Advanced Medical Systems, Inc.

Re: Advanced Medical Systems, Inc. - License No. 34-19089-01

CROSS-SECTION OF PROPOSED DRAIN SYSTEM
AMS London Rd

Revised 7-20-95

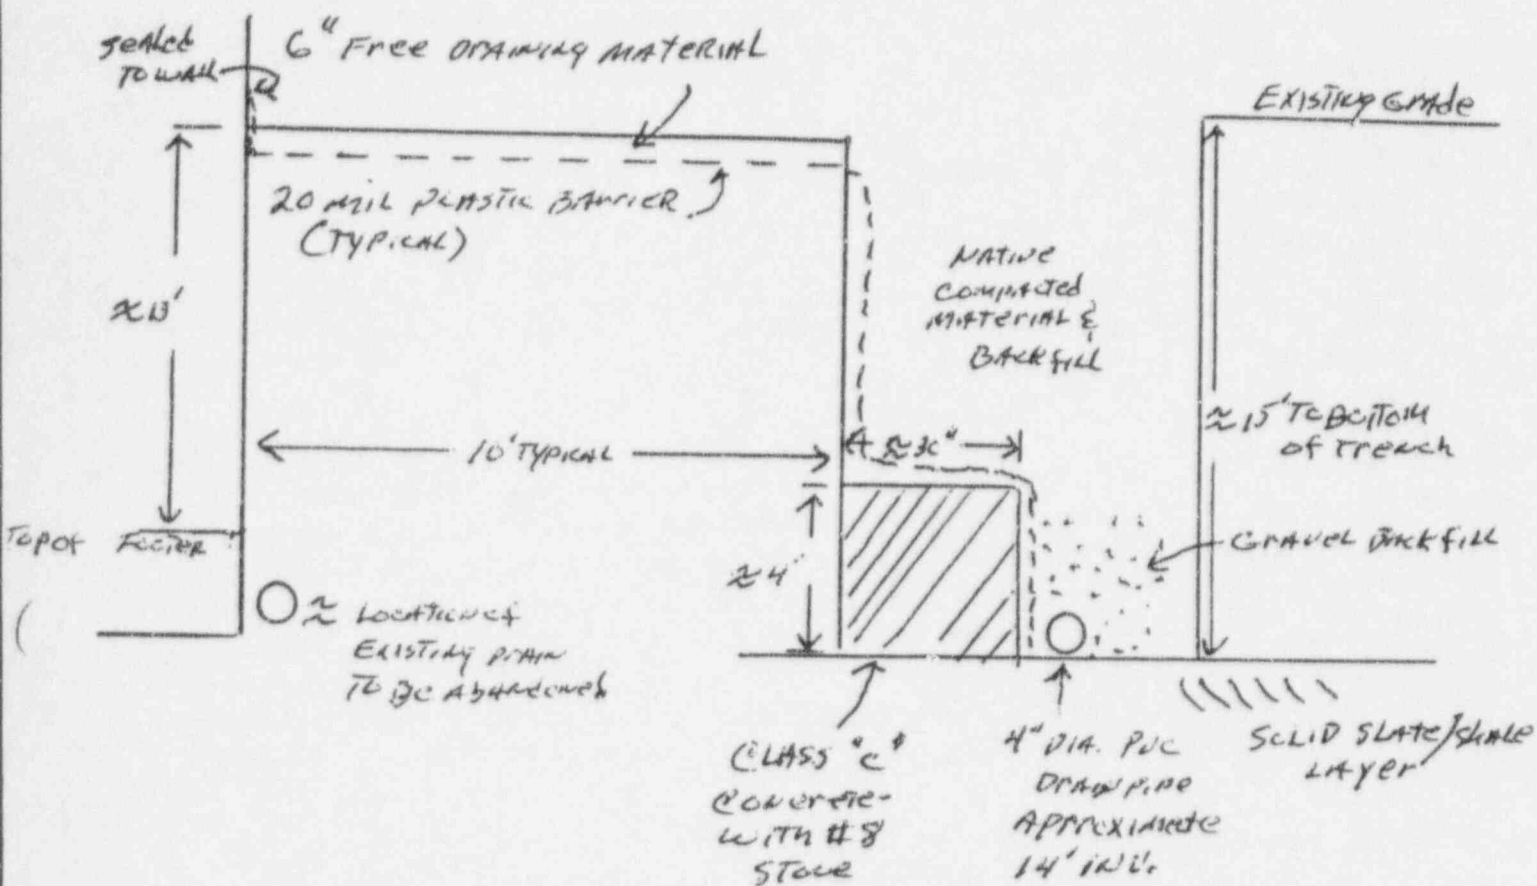
On July 29, 1995, Advanced Medical Systems, Inc. (AMS) transmitted to you plans for the final stages of the water treatment and sewer remediation project. Attached is a revision to Attachment 3 of that letter which showed the construction plans for the west side of the London Road building. This revision was presented to Mr. Wayne Slawinski and Mr. Robert Shewmaker of the USNRC on July 20, 1995, who concurred with the changes shown.

Reviewed with W. SHAWINSKI - NRC
R. SHAWMAKER - NRC
